**PC Case 20-09 – Multiple applications for the redevelopment of 1571 Robert Street South and the construction of a five story mixed use building offering 187-unit market rate apartment and 5,000 square feet of retail. – Roers Companies**

## **Case 20-09 – Plan Review for Town Center One Redevelopment**

Re: Wentworth Apartments Stormwater Review  
WSB Project No. 013770-000

### Drive Aisles & Stall Dimensions

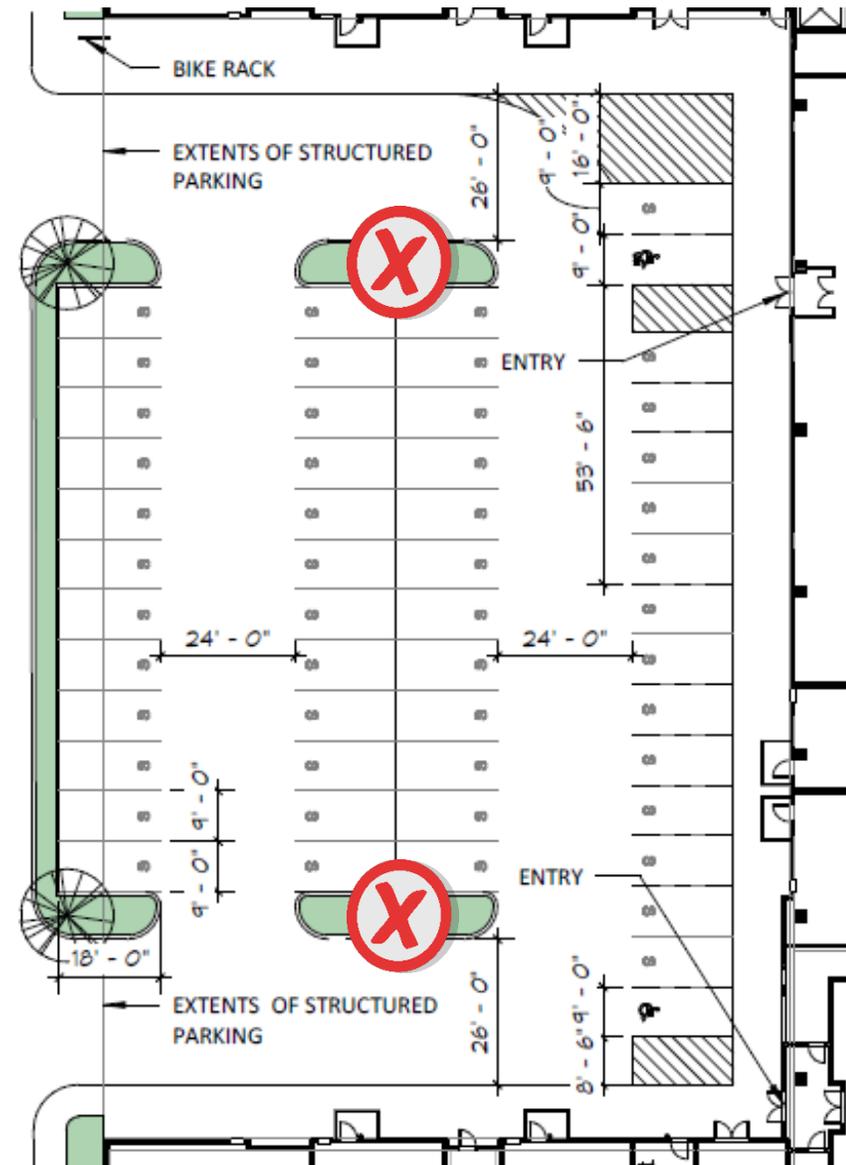
- Drive aisles (24 – 26ft) – Meets code ✓
- Parking stall width (9ft) – Meets code ✓
- **Parking stall depth 18ft – Code (20ft)\***
  - Majority of stalls on site are 18ft deep
  - Site offers 2 compact stalls at 16ft deep
- All curbing will be B-6-12 – Meets code ✓
- Curbed islands have trees
  - With the exception of the middle islands in the central parking lot – directly above parking garage

### Access – Robert St

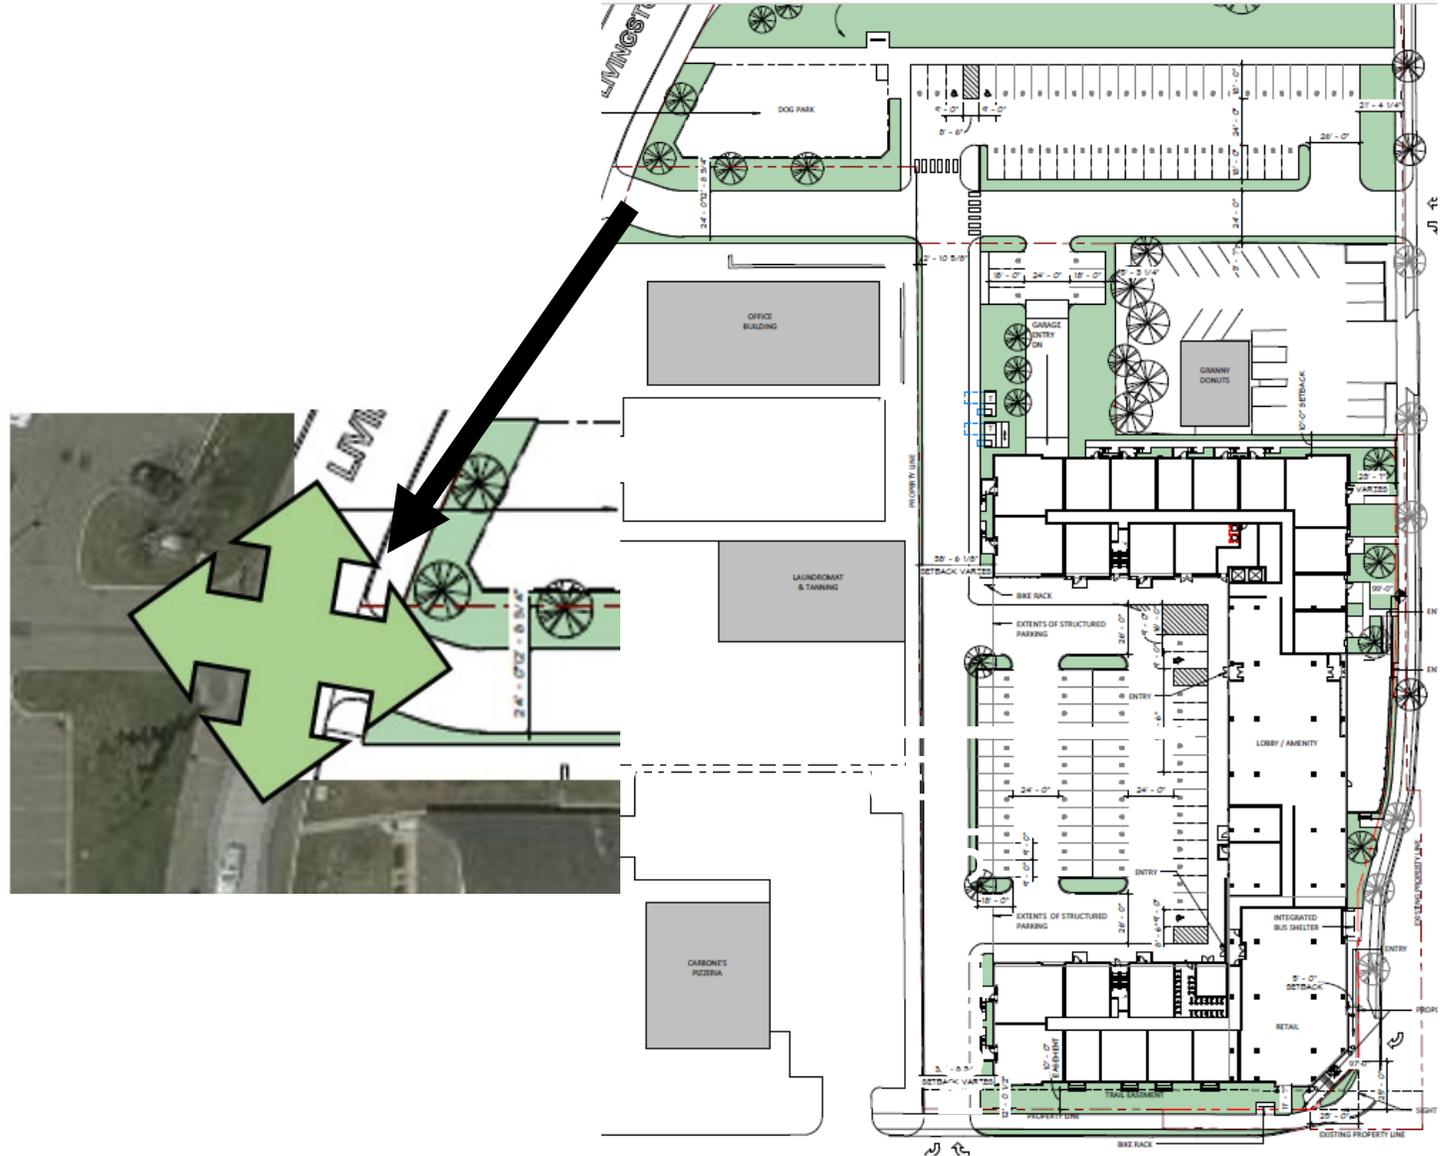
- Robert St. is a MnDot road
  - Similar to the County, less is more for access
- MnDot Review:
  - Limiting access points down to one,
    - Granny Donuts entrance will remain
- Staff is recommending as a condition of approval that the applicant adhere to the MnDot recommendations and requirements as outlined in the memo dated August 11, 2020.

#### Buffer Trees

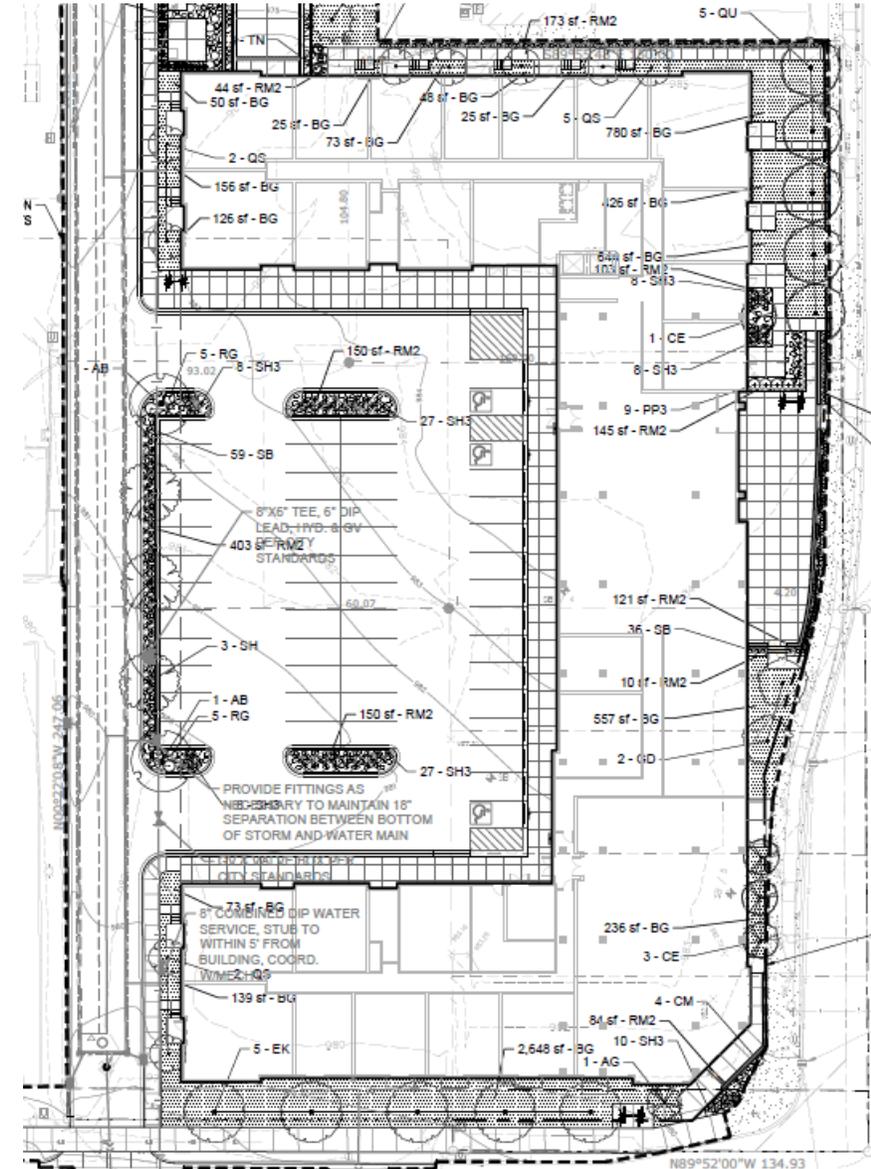
- 1 tree per 40ft of property line
  - Equates to 56 trees

- No irrigation plans submitted
- City Staff is recommending as a condition of approval that an irrigation plan be submitted with the building permit

### Dakota County Plat Commission

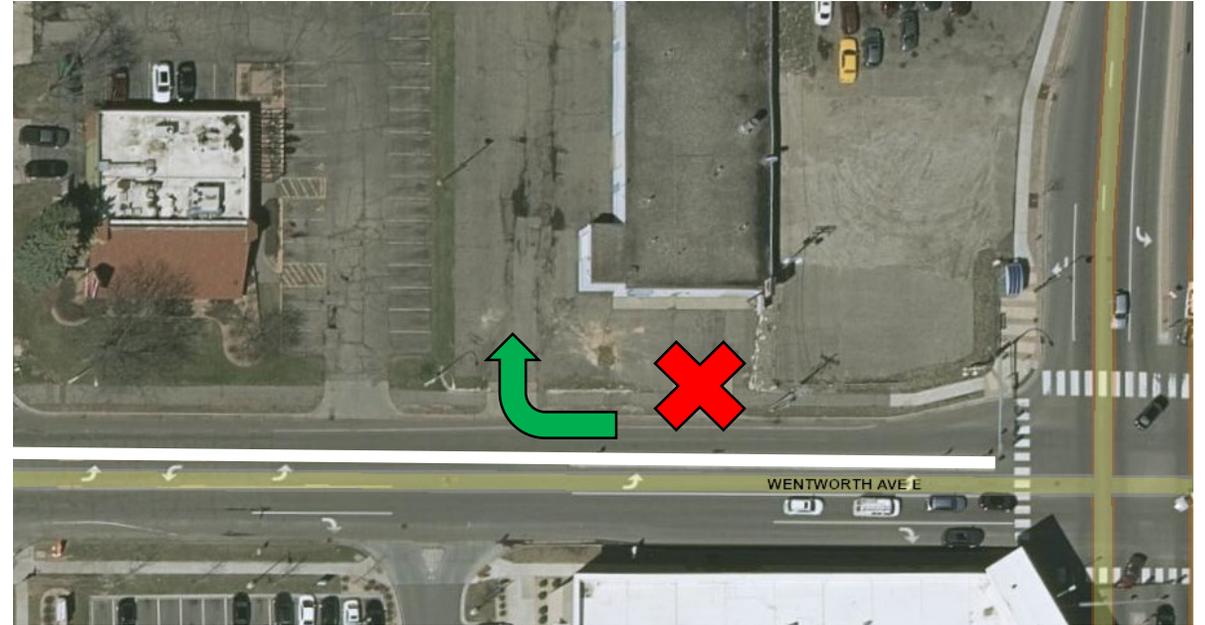
Dakota County Plat Commission reviewed the plat at their August 5<sup>th</sup> meeting and recommended the following:
